TRACT MAP NO. 73336

TENTATIVE MAP DATED <u>06/15/16</u> EXHIBIT MAP <u>06/15/16</u>

MAJOR SUBDIVISION **VESTING TENTATIVE** TRACT NO. 073336

X:\Civil3D\5090-033\Tentative Maps\NorthLake TM 73336 Sheet 1.dwg, 1:1

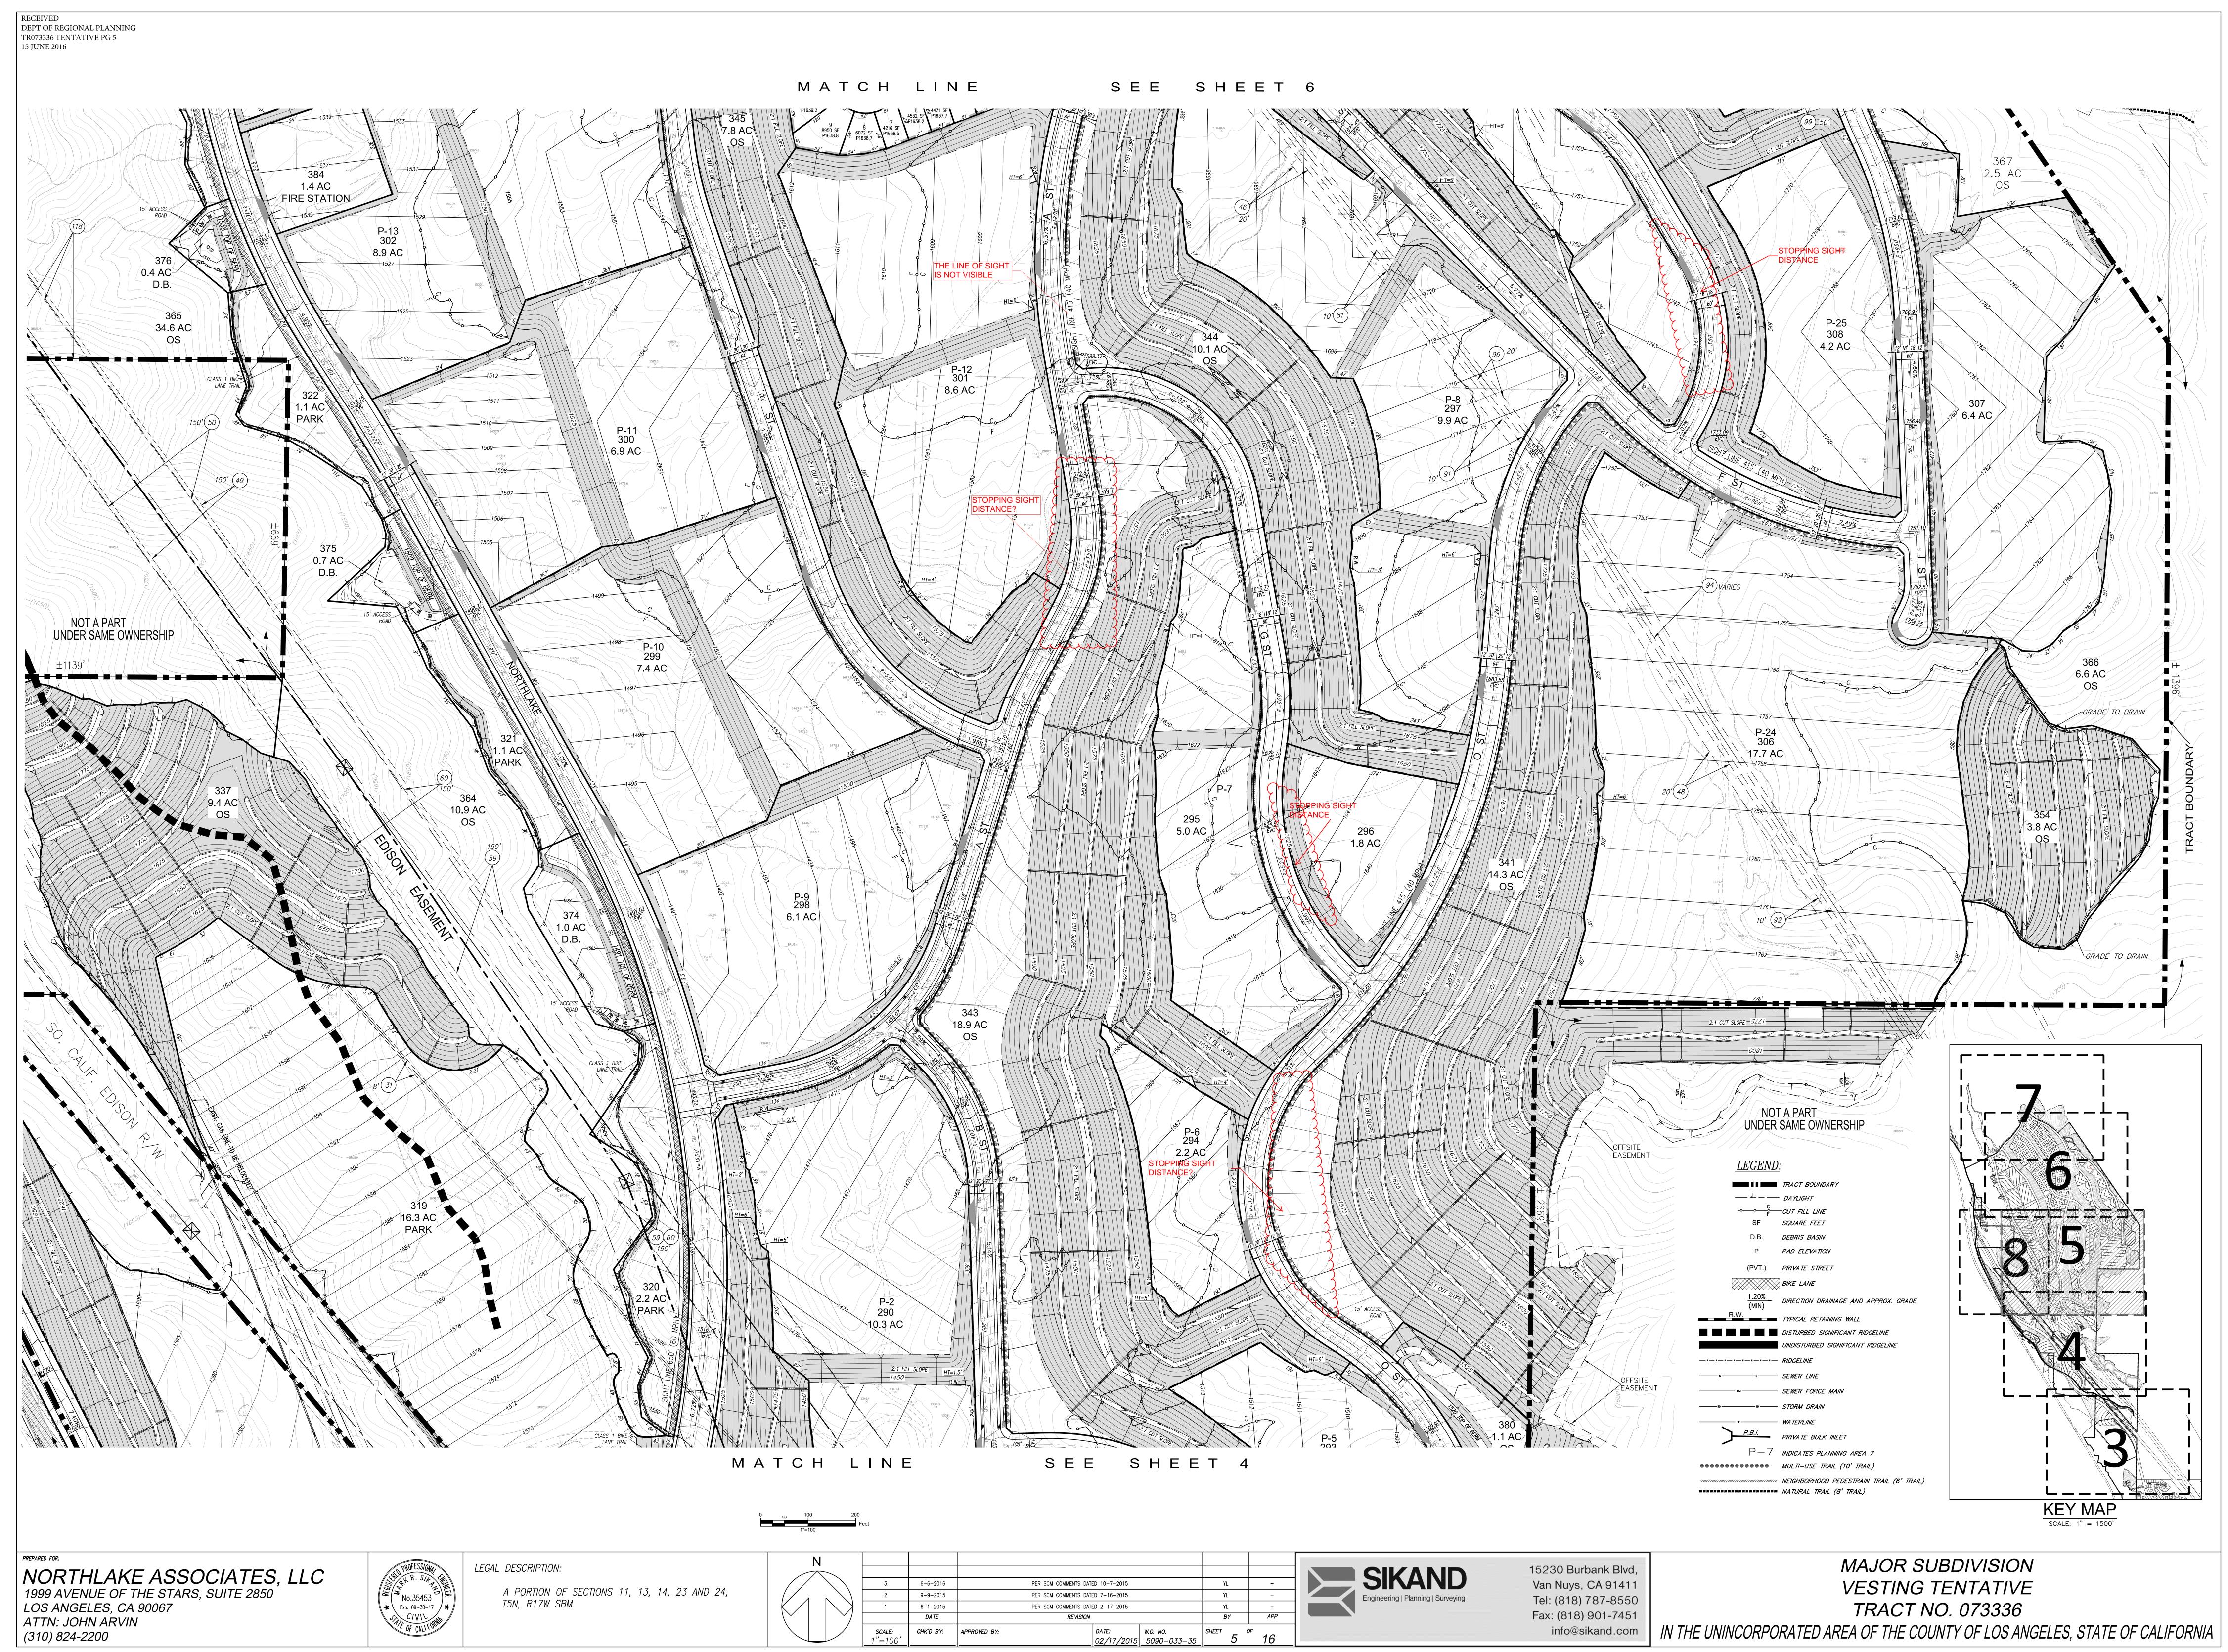
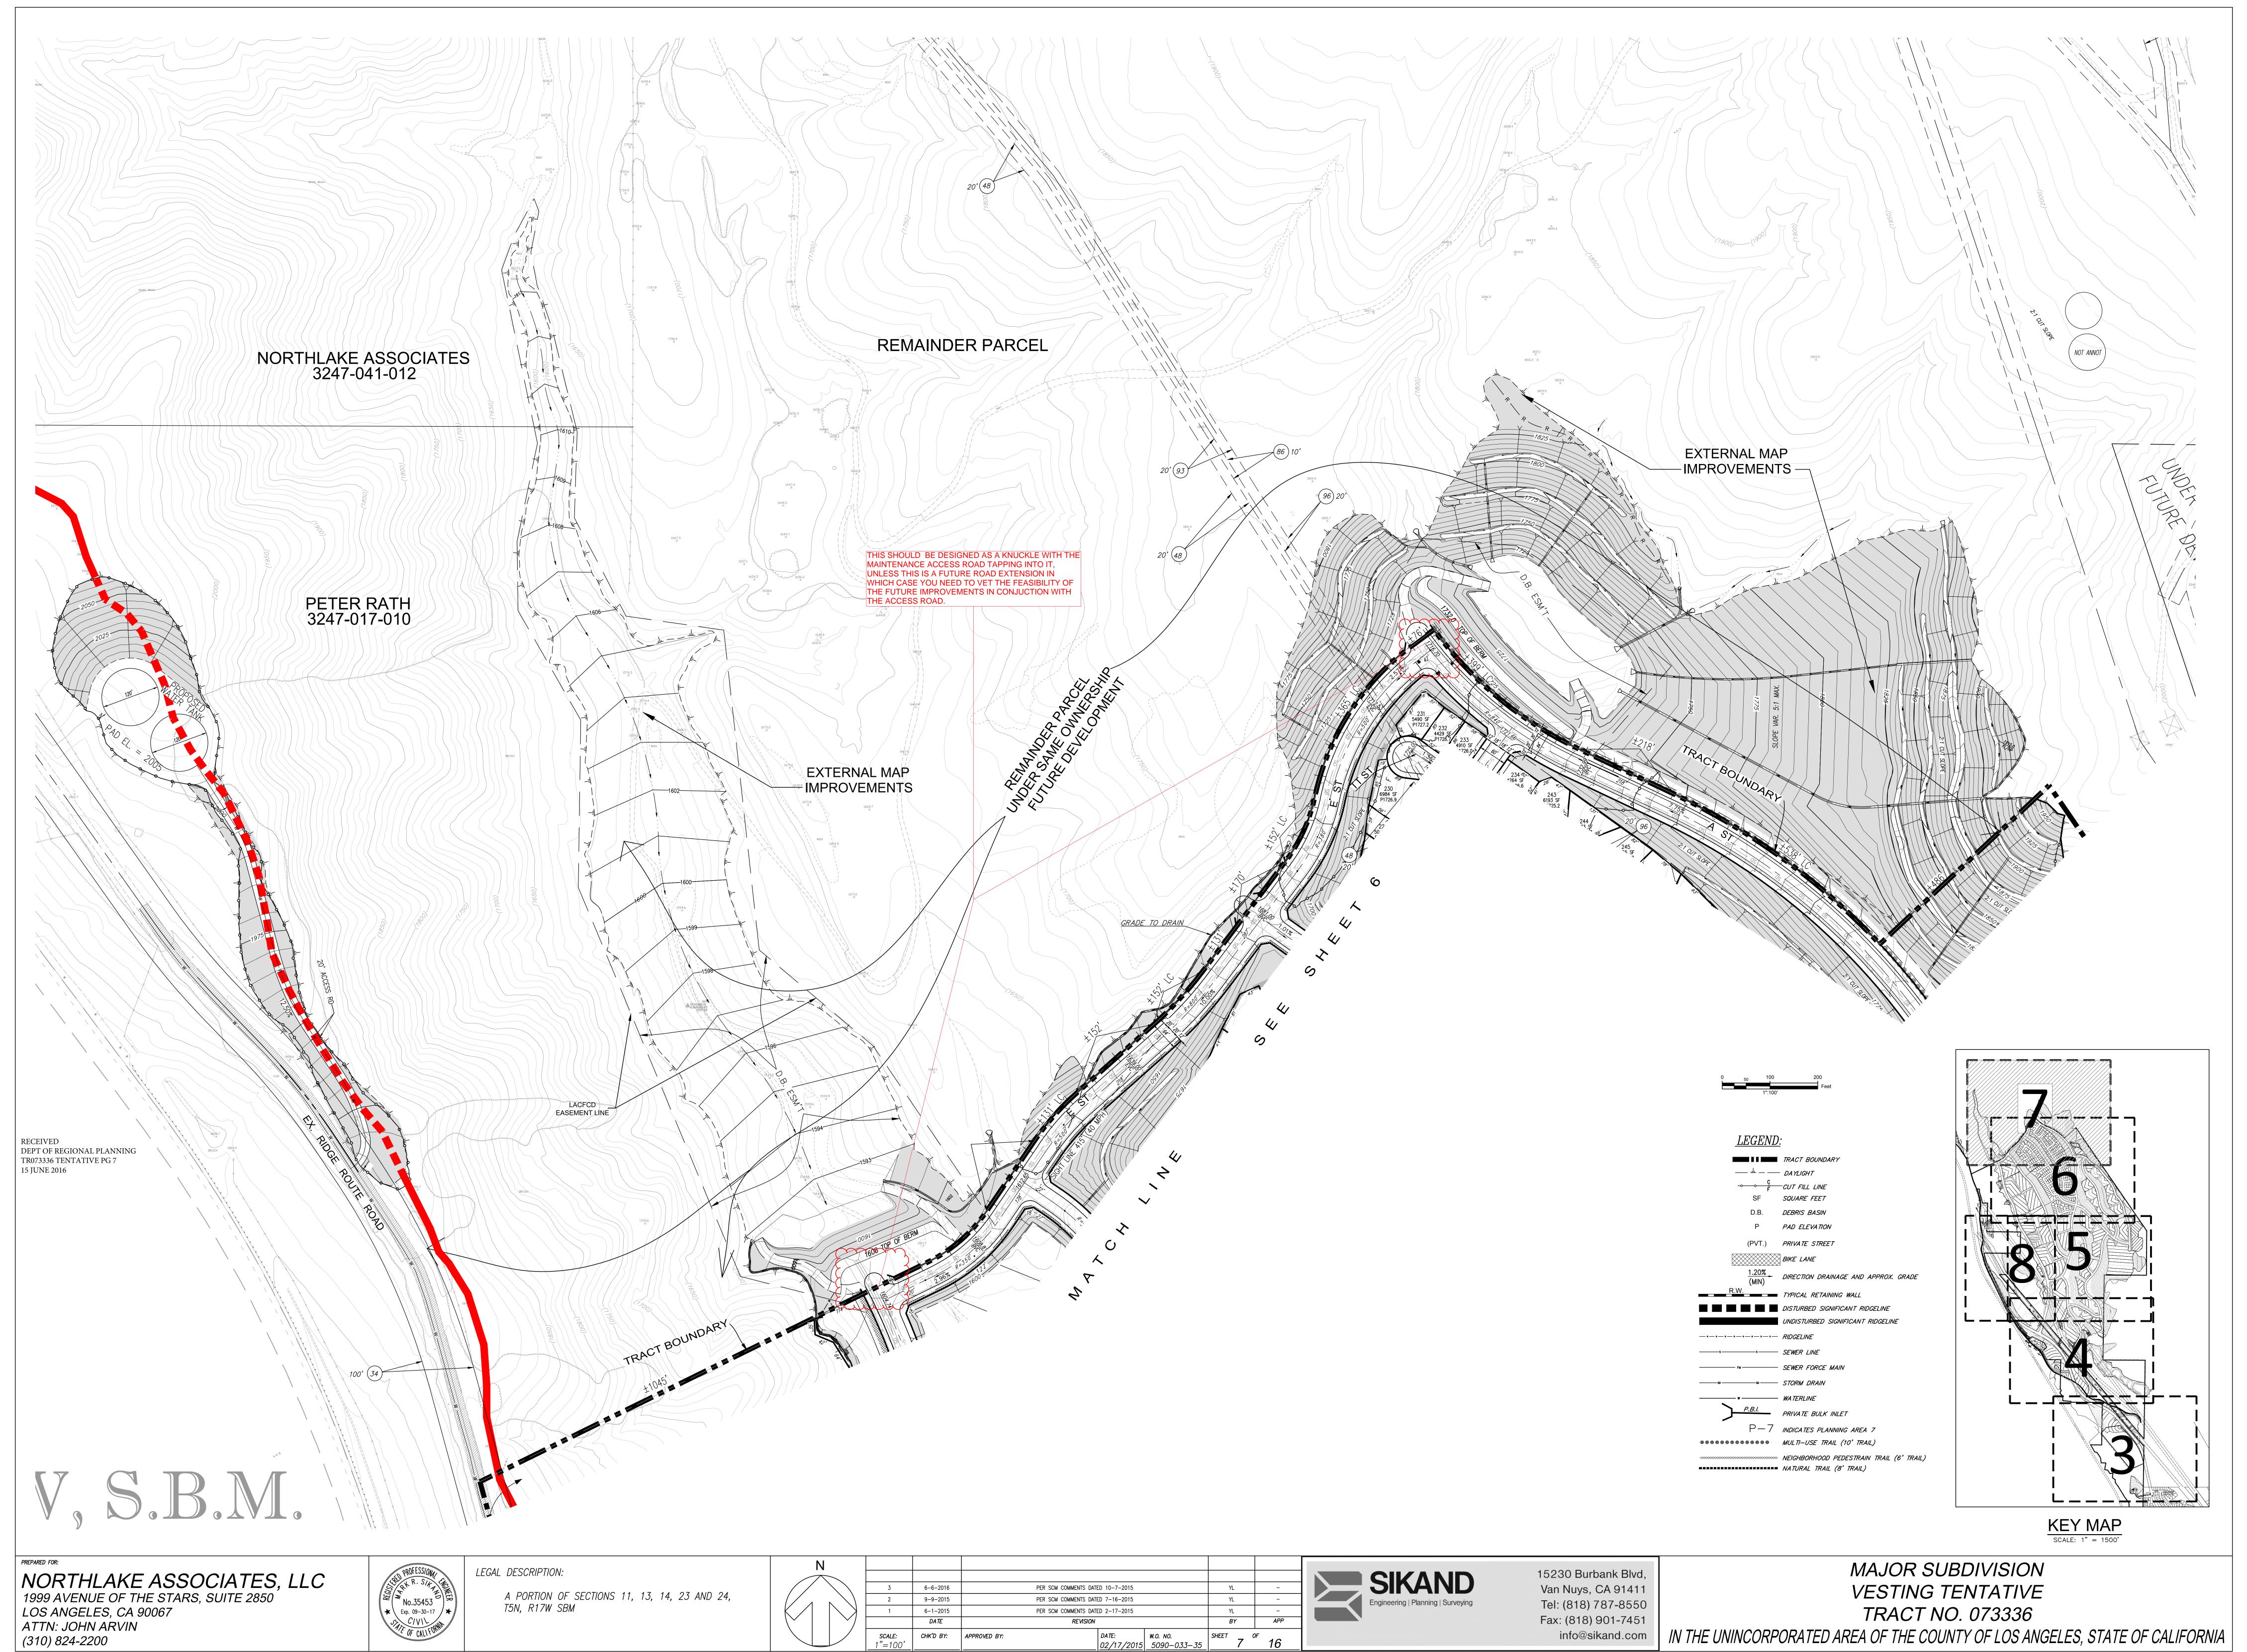
- 1. Traffic Study will be required. Please contact Andrew Ngumba of Traffic and Lighting Division, Traffic Study section at (626) 300 4851 for requirements.
- 2. A revised tentative map and exhibit map are required to show the following items:
  - a. See attached for comments.
